Docket Number:	24-OPT-04
Project Title:	Potentia-Viridi Battery Energy Storage System
TN #:	263577
Document Title:	CEC Data Request #2 - Visual Resources Response
Description:	This document responds to the CEC's 4/7/25 second deficiency request as it relates to Visual Resources.
Filer:	Ronelle Candia
Organization:	Dudek
Submitter Role:	Applicant Consultant
Submission Date:	5/30/2025 2:37:13 PM
Docketed Date:	5/30/2025

CEC Data Request #2 – Visual
Resources Response

Potentia-Viridi Battery Energy Storage Project

Revised Scaled Elevation Drawings

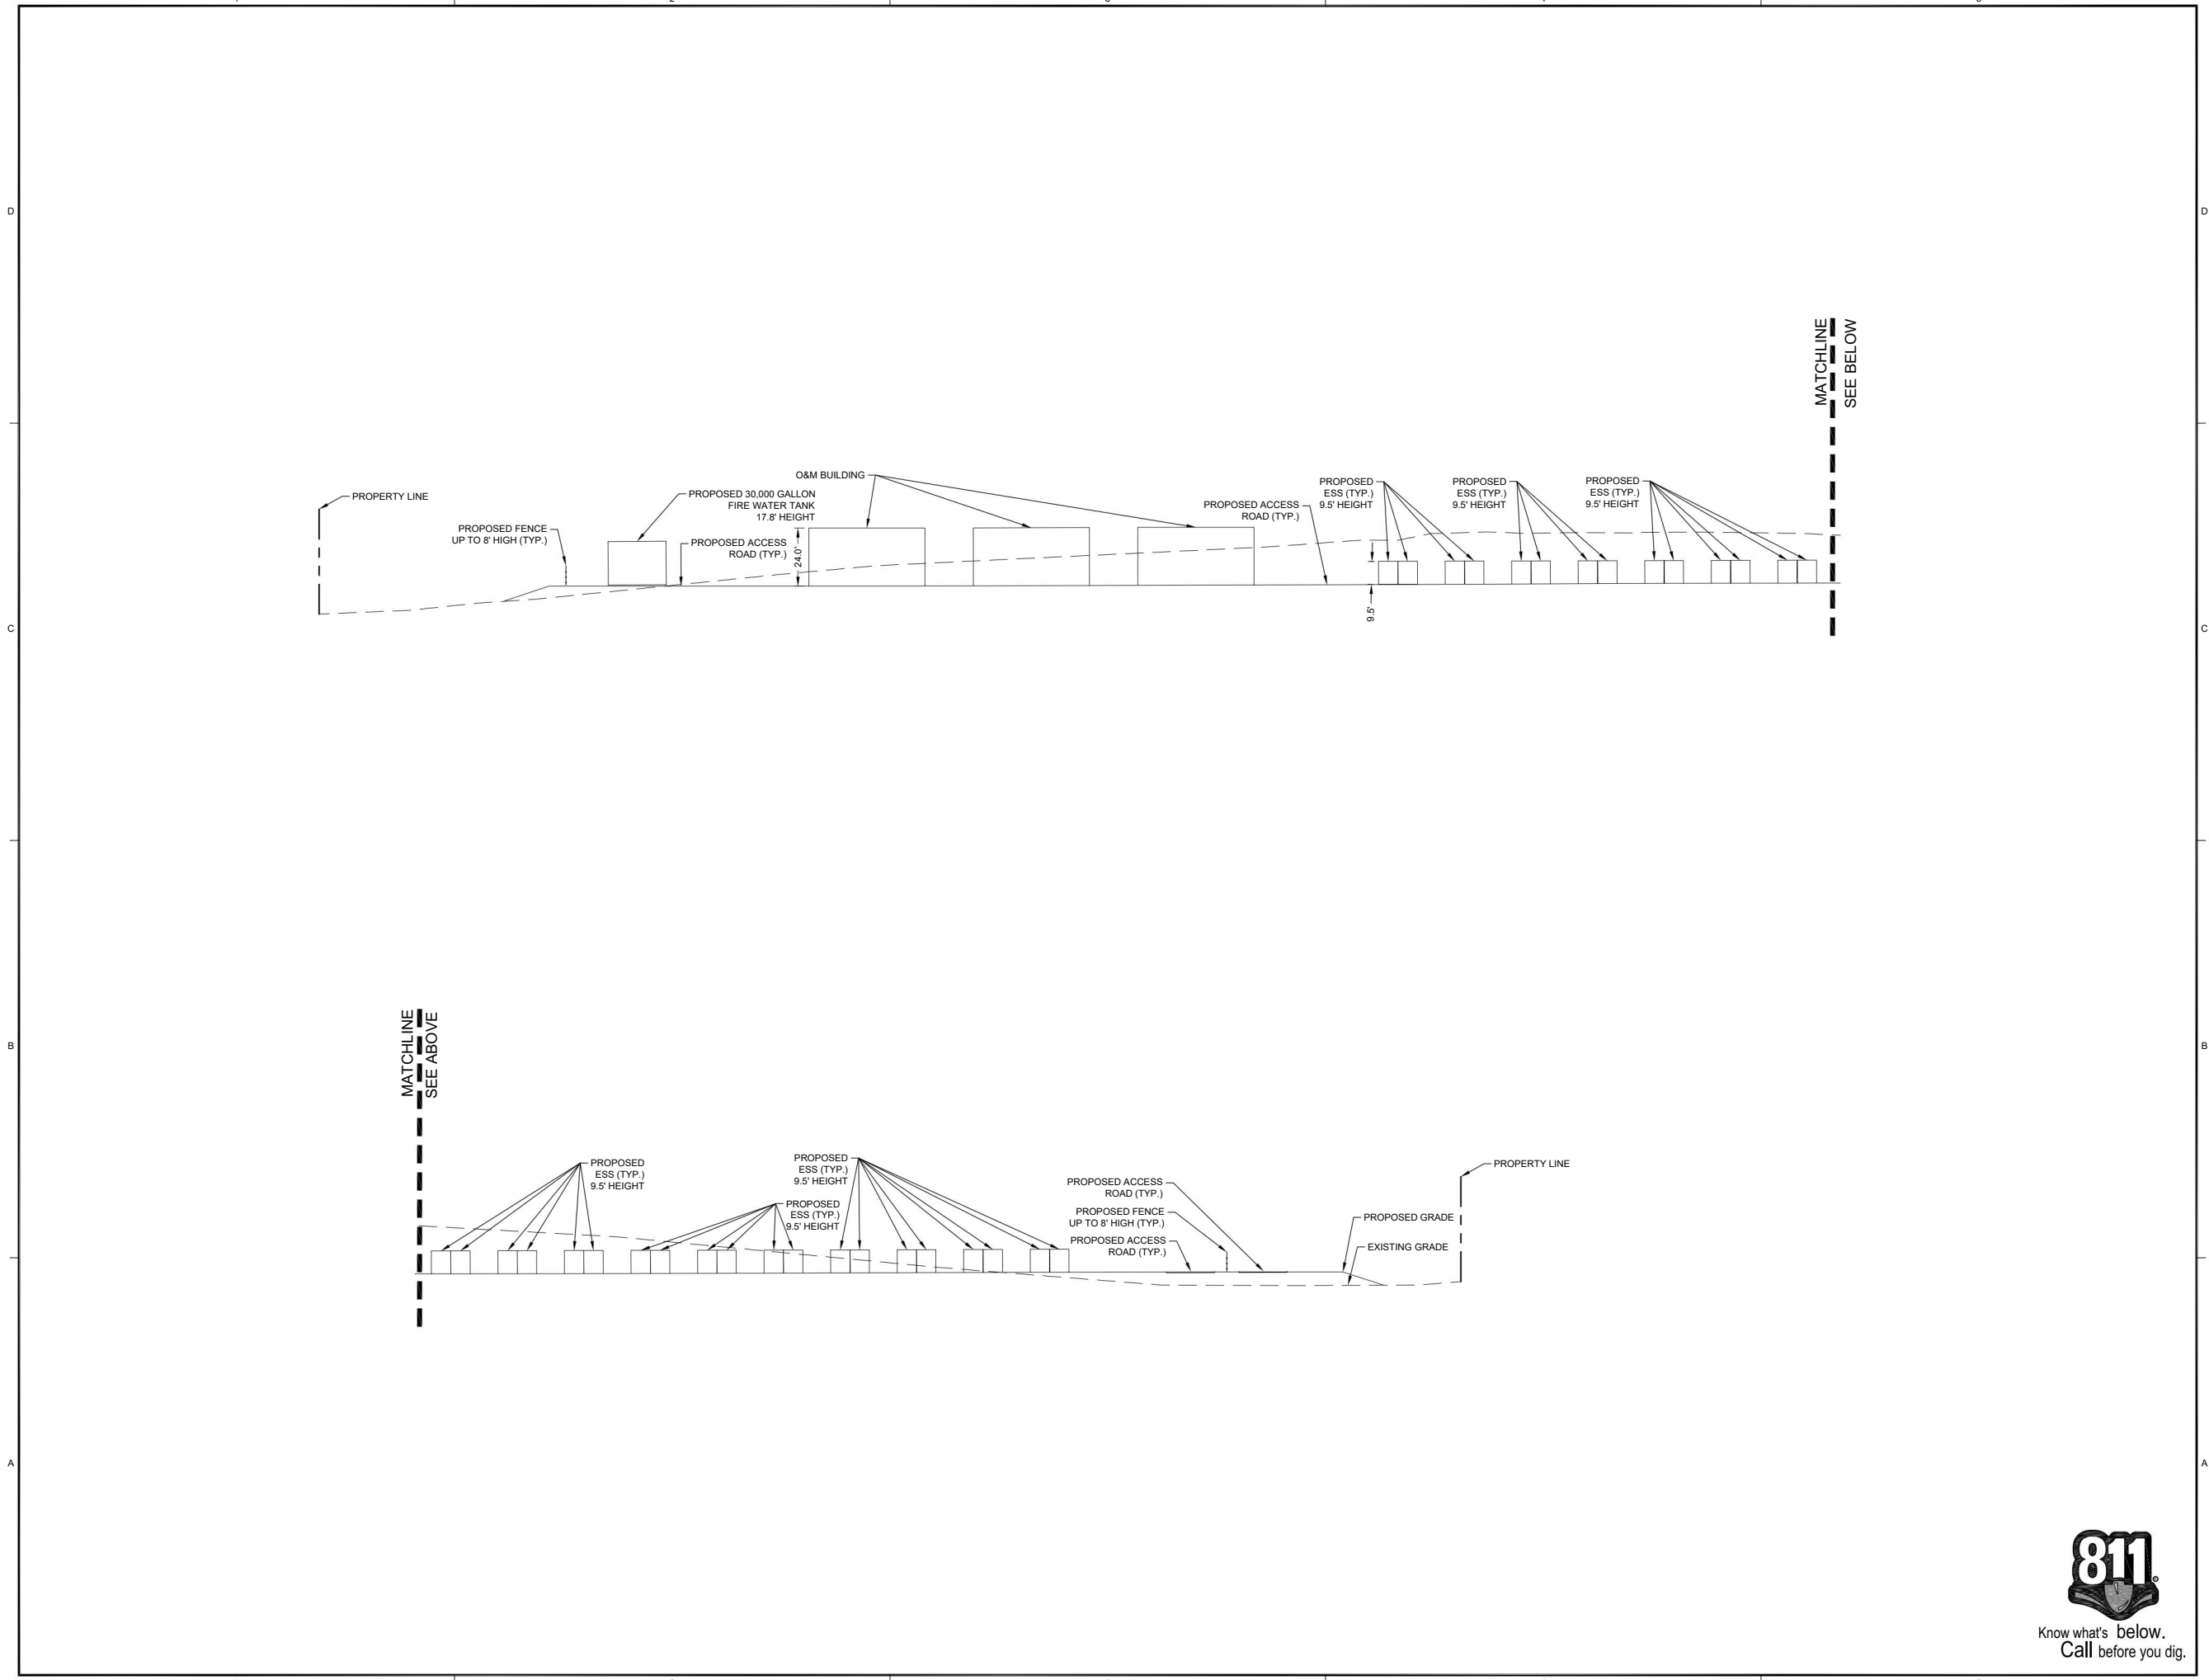
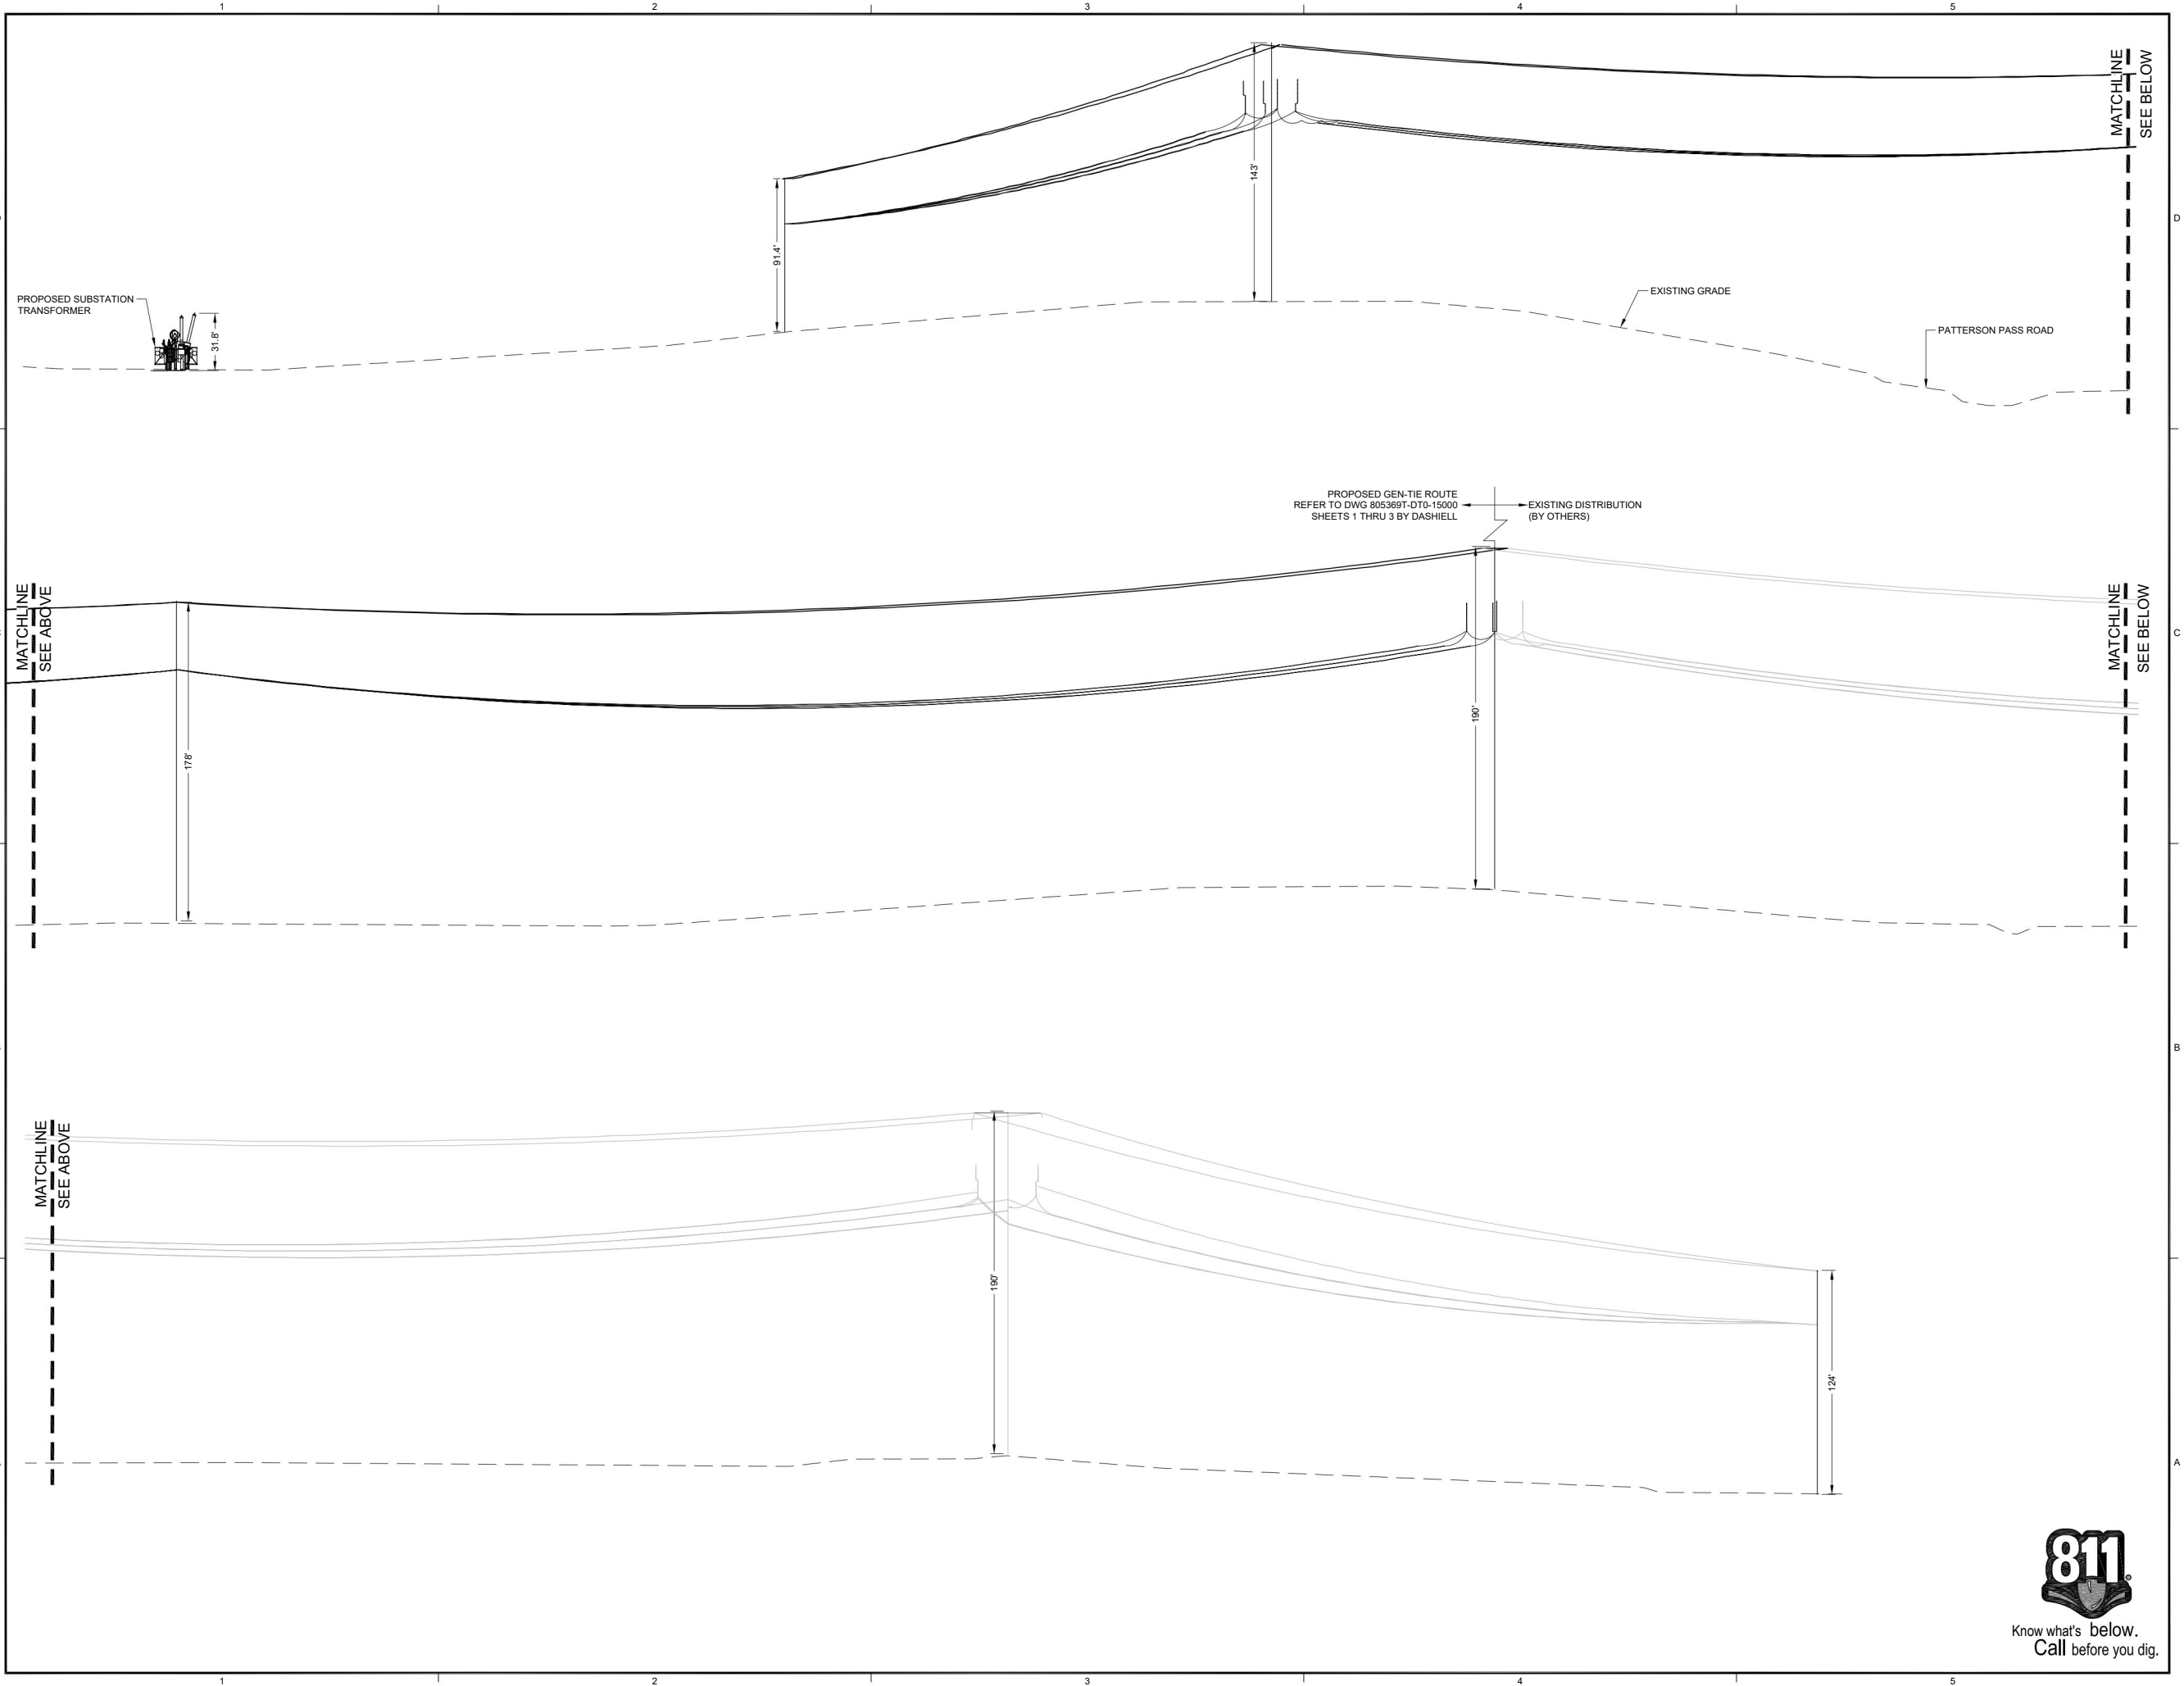
REV DR VIS-1. *Please add the following information to the scaled elevation drawings provided on Sheets C-1.2 and C-1.3 of Attachment 16 Civil Plans.*

- *BESS enclosure heights*
- *Substation transformers and heights*
- *Gen-Tie Line Poles*
- *30,000 Gallon Fire Water Tank*

Response: Refer to Attachment 1 for revised scaled elevation drawings.
